**City of Lake Elmo  
Planning Commission Meeting  
Minutes of June 8, 2015**

PLANNING COMMISSION  
DATE: 6/22/15  
AGENDA ITEM: 4A – PUBLIC HEARING  
CASE # 2015-19

The City of Lake Elmo has received a request from Lennar Corporation for a preliminary plat for a 46 unit townhouse development tentatively called the Diedrich Property Preliminary Plat. Please note that the original application and all of the construction plans as submitted were for a 48-unit project utilizing a private street. Due to several issues concerning the original configuration of lots and in order to address City, County, and watershed district comments and concerns, the applicant has submitted a revised site plan that now includes a public street and a reduced number of lots. The applicant may still be seeking some variation from City standards in order to plat a public street, and Staff is suggesting that any variations from the City’s zoning and subdivision regulations be addressed at the final plat stage.

Re: Diedrich Property – Preliminary Plan Review

6 OF 14

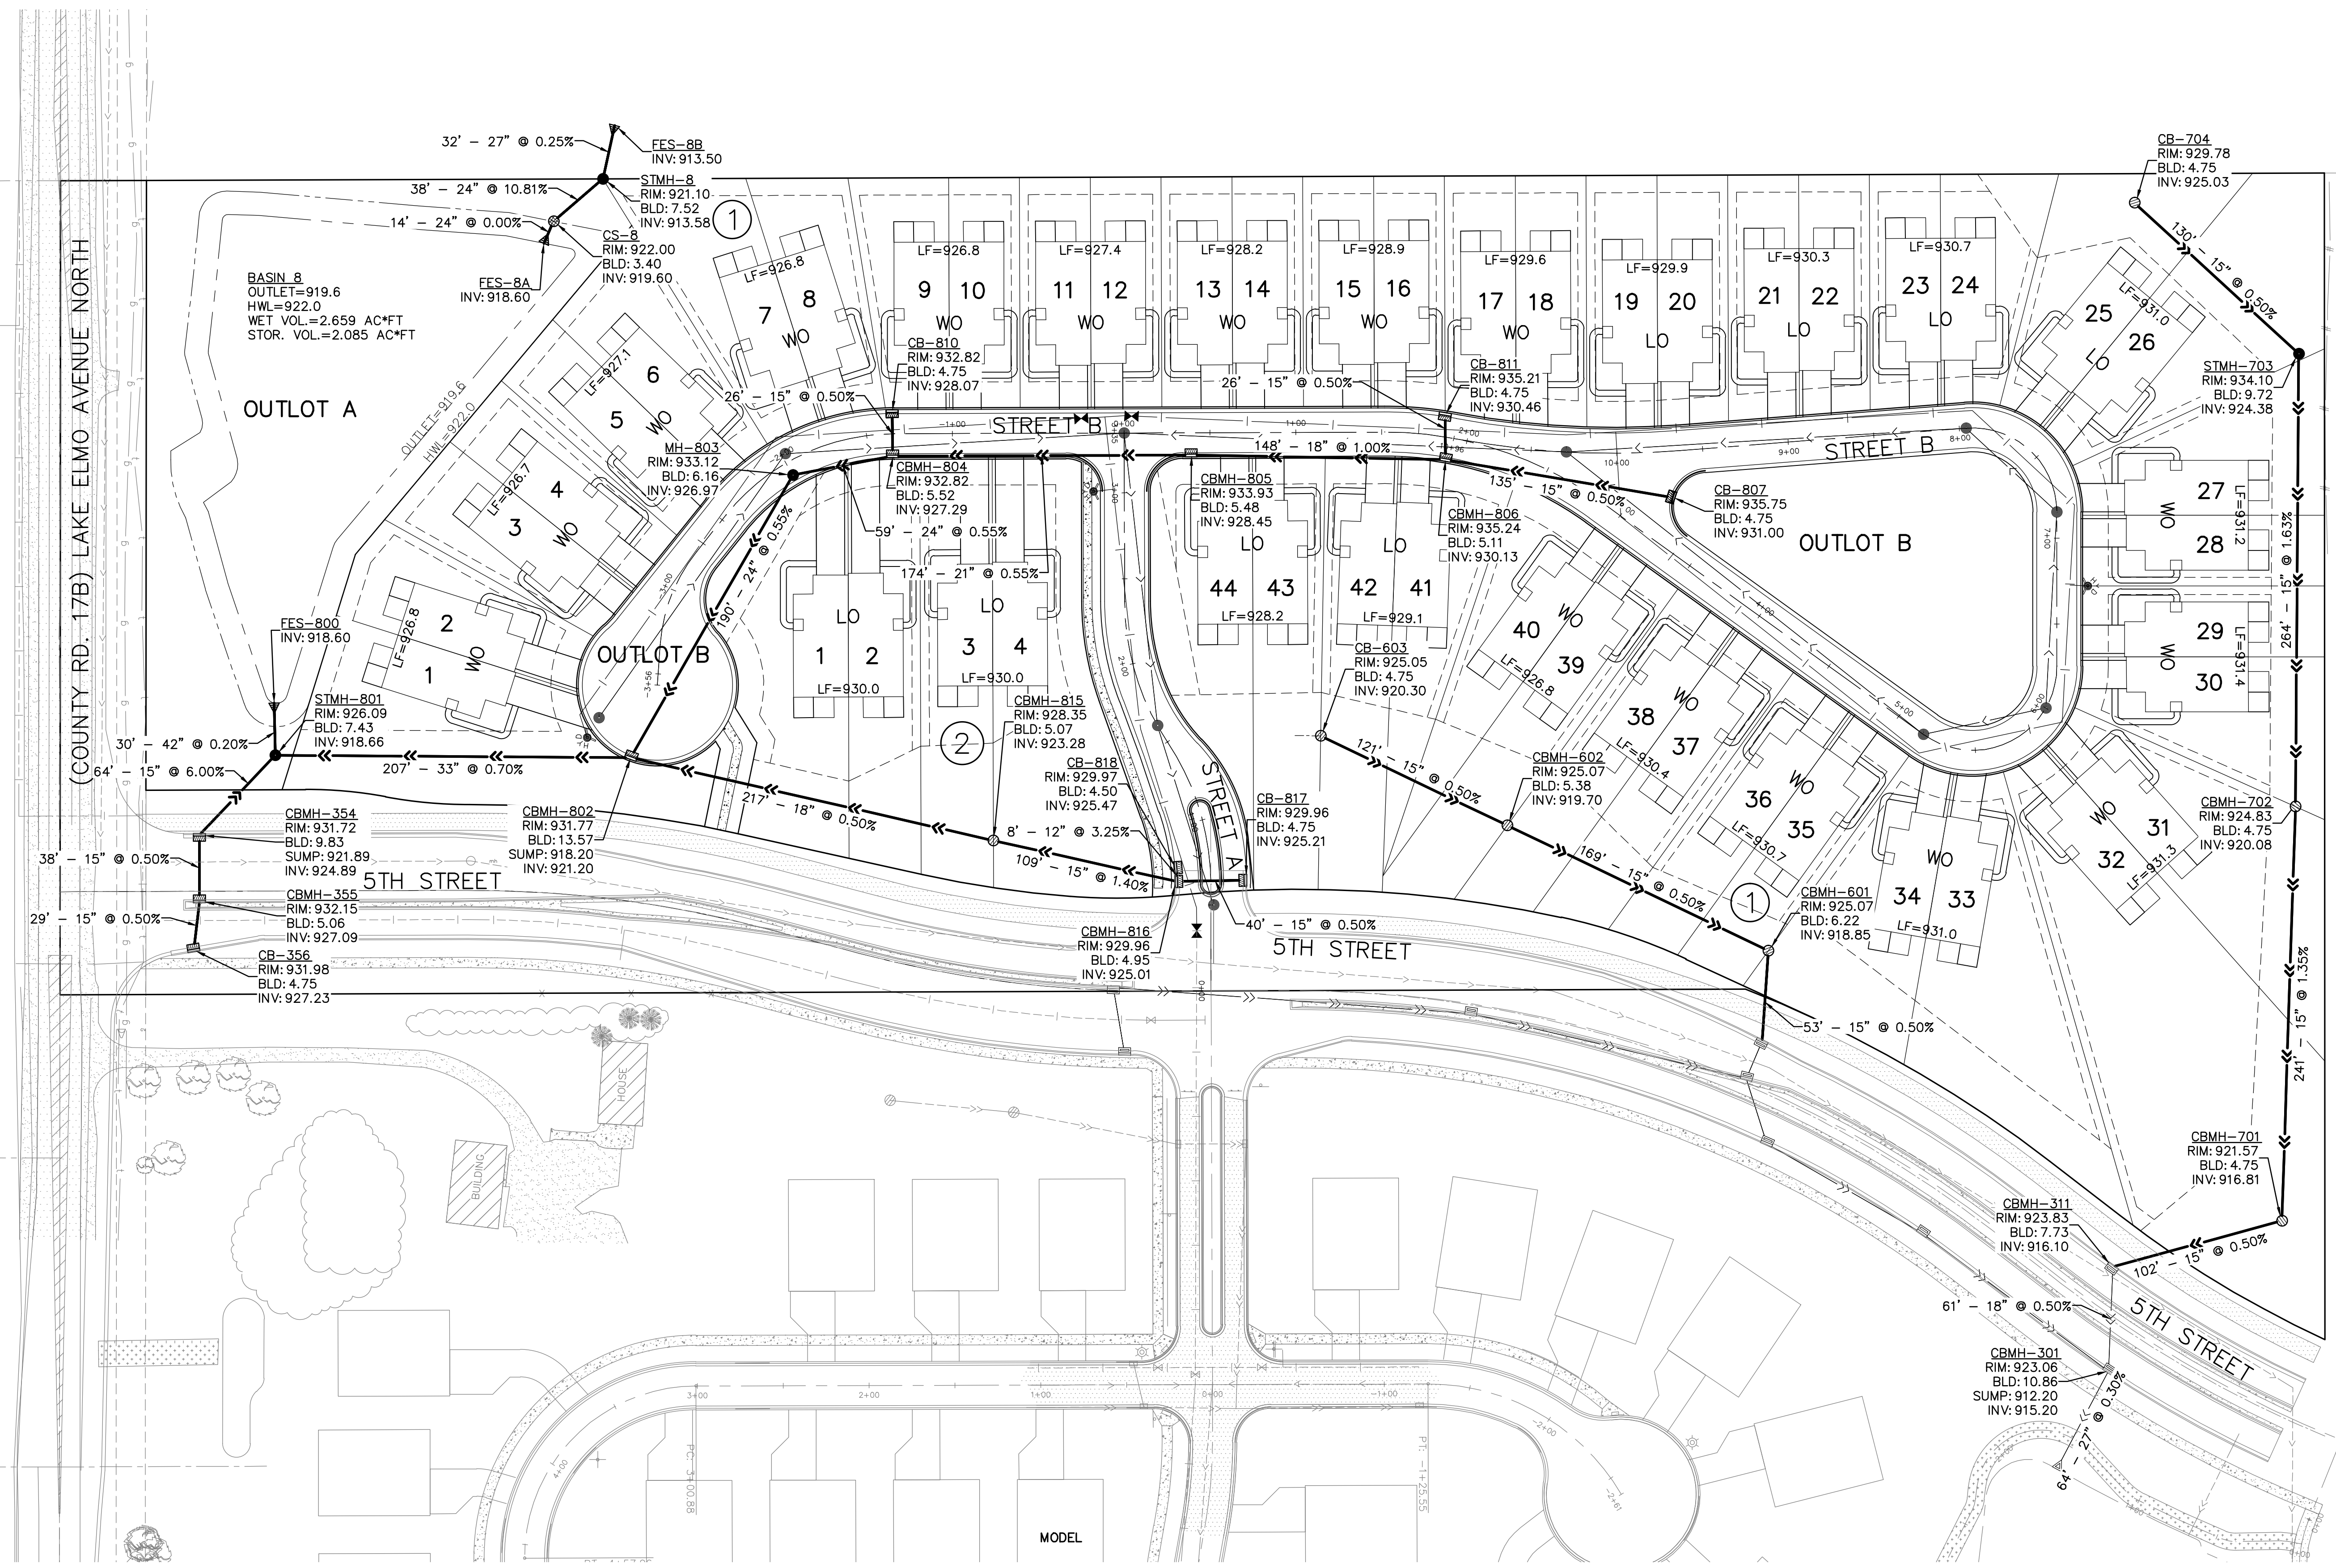
- Street A vertical alignment should be revised to provide a  $K = 37$  minimum at STA 0+71.00.

STORM SEWER

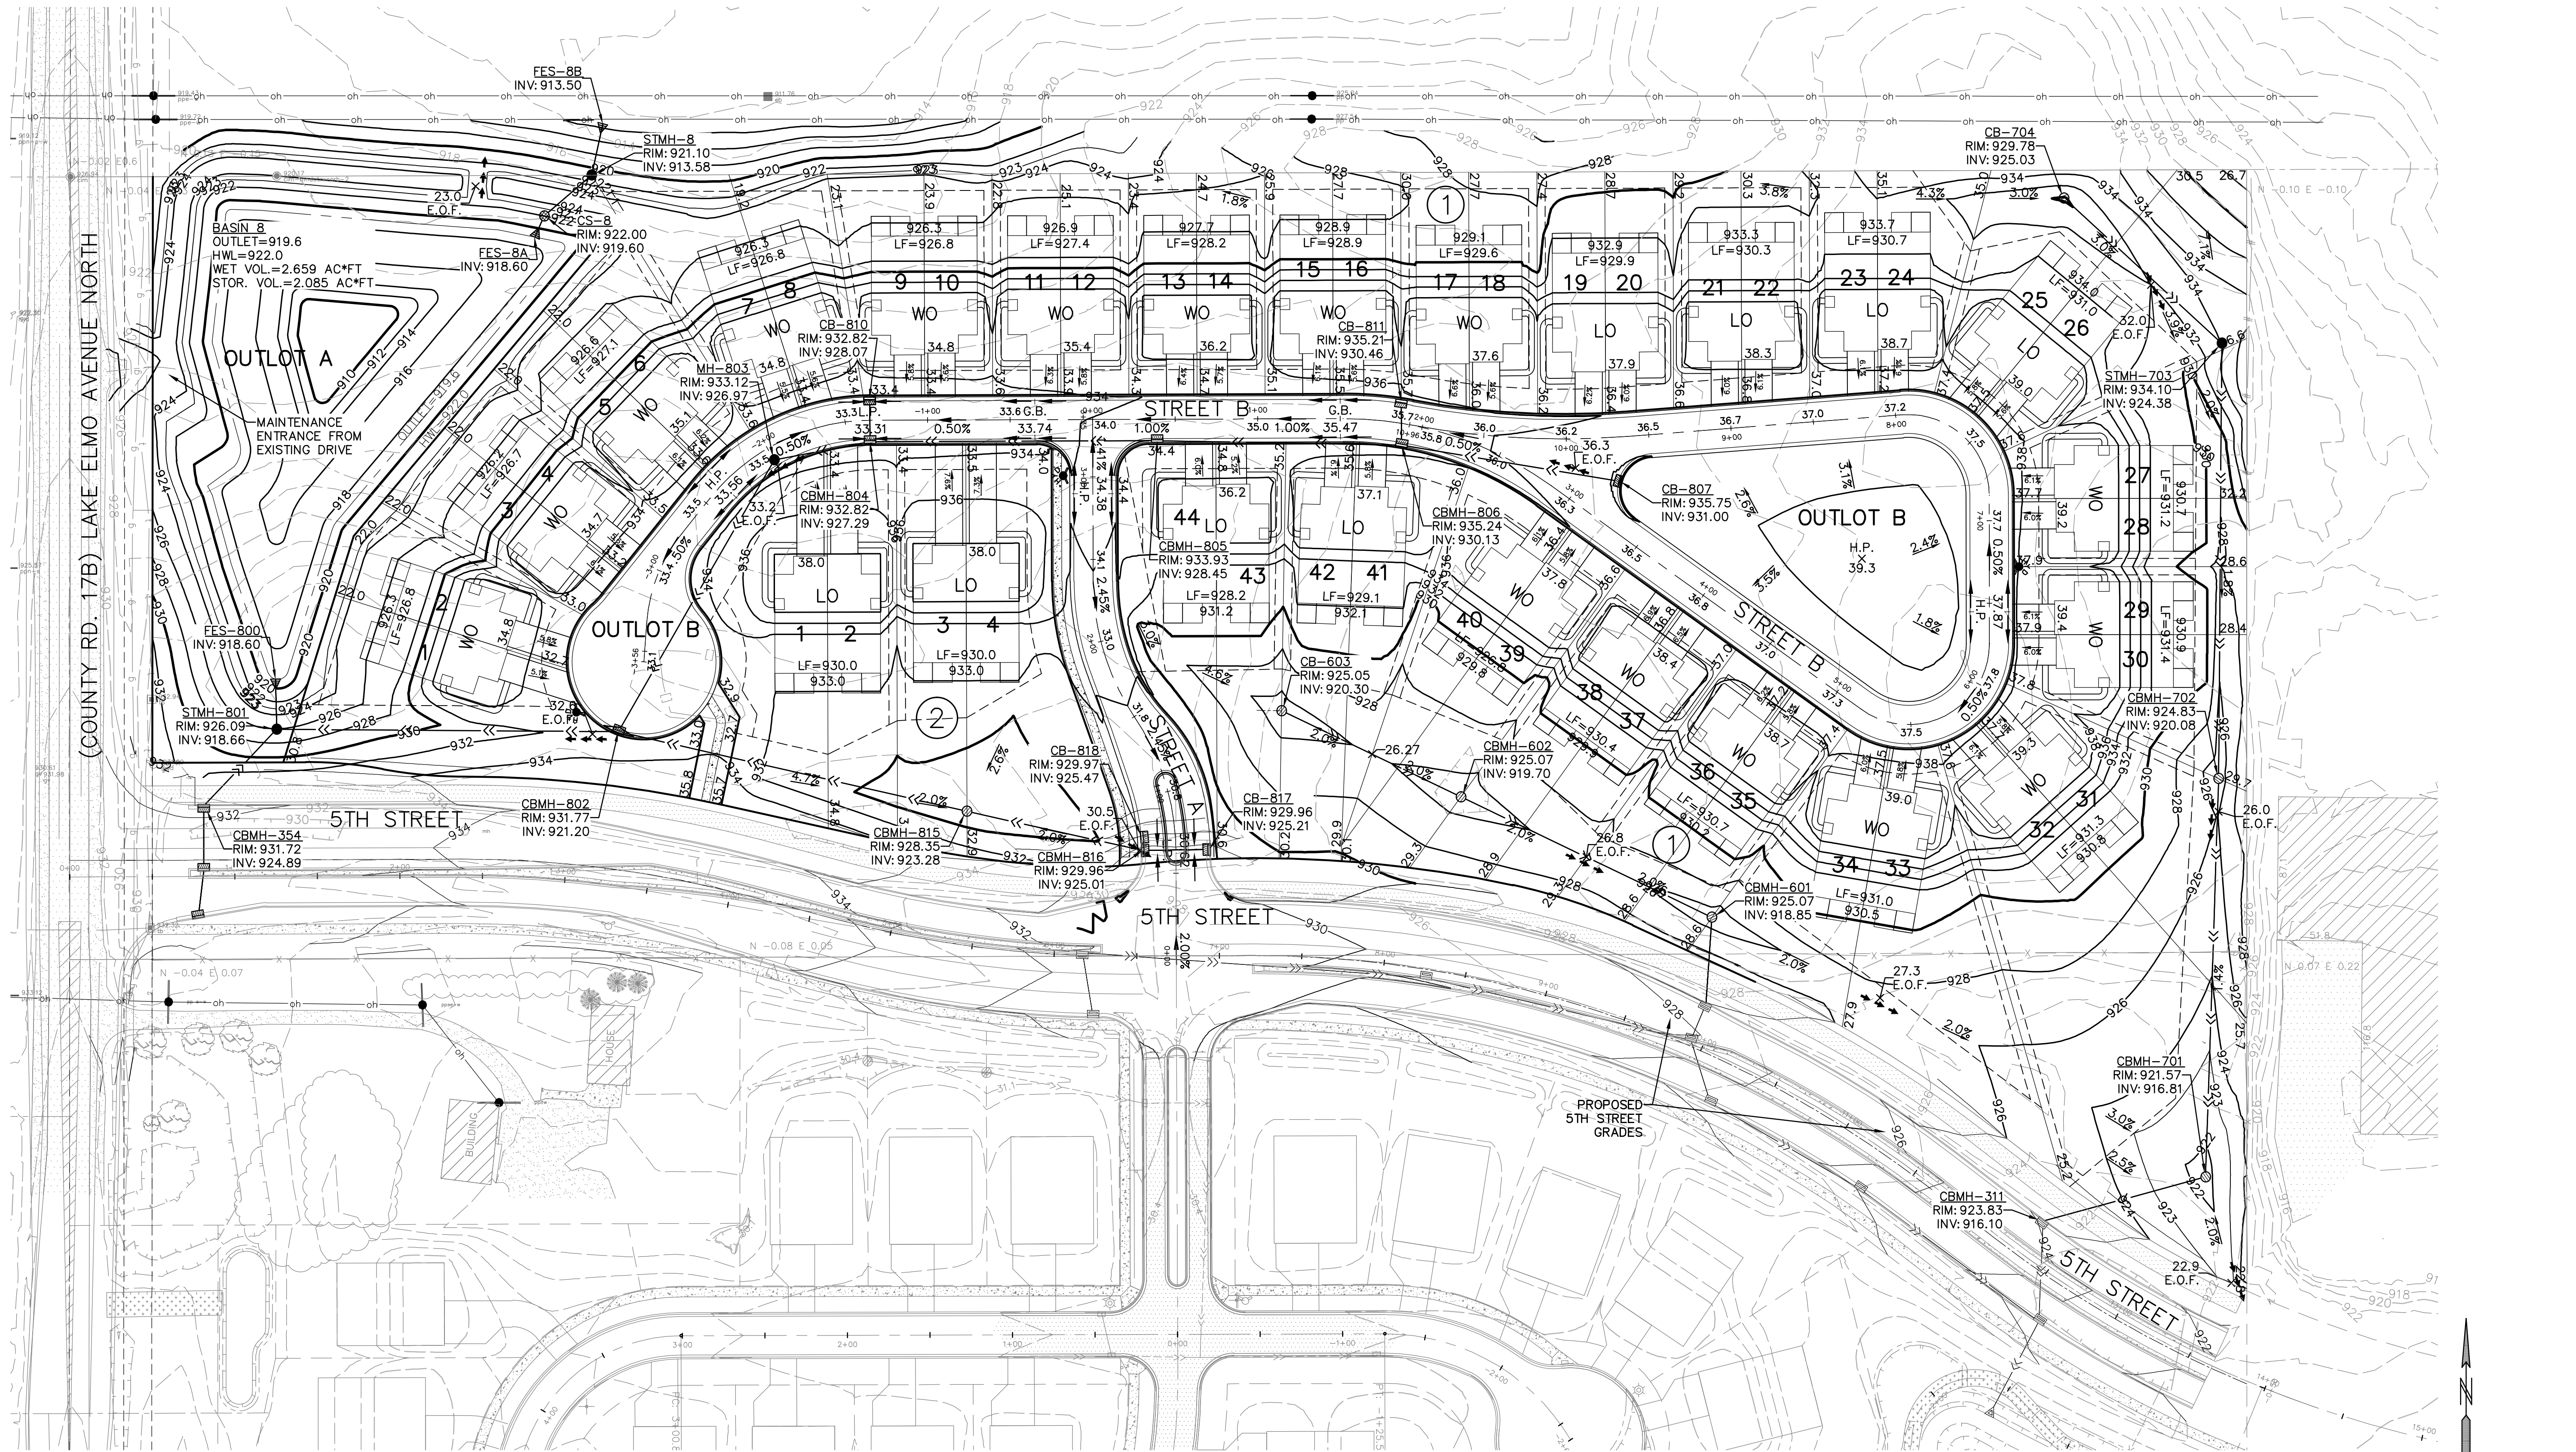
- The site plan is subject to a storm water management plan meeting State, VBWD and City rules and regulations. Storm water facilities proposed as part of the site plan to meet State and VBWD permitting requirements must be constructed in accordance with the City Engineering Design Standards Manual available on the City website. A finalized storm water management plan must be approved by the City and the VBWD permit must be obtained prior to grading activities.
- The Stormwater Management Plan incorporates storm water re-use through lawn irrigation. The re-use system is necessary for the applicant's plan to meet State and Watershed permit requirements for water quality treatment (volume control). Outlot A is proposed as City owned to accommodate the storm water

- The storm water pond must be designed and constructed in accordance with the City Engineering Design Standards.
  - A detailed design of the irrigation system together with a detailed operations and maintenance plan must be submitted prior to any grading or construction activity on the site.

- The pond grading must be revised to add a 10-foot maintenance bench around the entire pond, per the standard pond detail.
  - The maintenance access road must be revised to access the pond from 5<sup>th</sup> Street North, not CSAH 17.

- Overland emergency overflows or outlets will be required as part of the site plan and must be located within drainage easements, must be in Bold Type on the plans, and must provide 1 foot of vertical separation to the low opening of any building structure. Lot information details must include the lowest opening in addition to the lowest floor elevation.

- The ultimate discharge rate and location is an important consideration to avoid negative impacts to downstream properties. The storm water management plan indicates the pond outfall pipe to discharge to the northerly property. The plan as proposed cannot be implemented without permanent drainage and utility easements from the adjacent property. Permission should be provided to the City prior to accepting a final plat application or allowing grading activities.
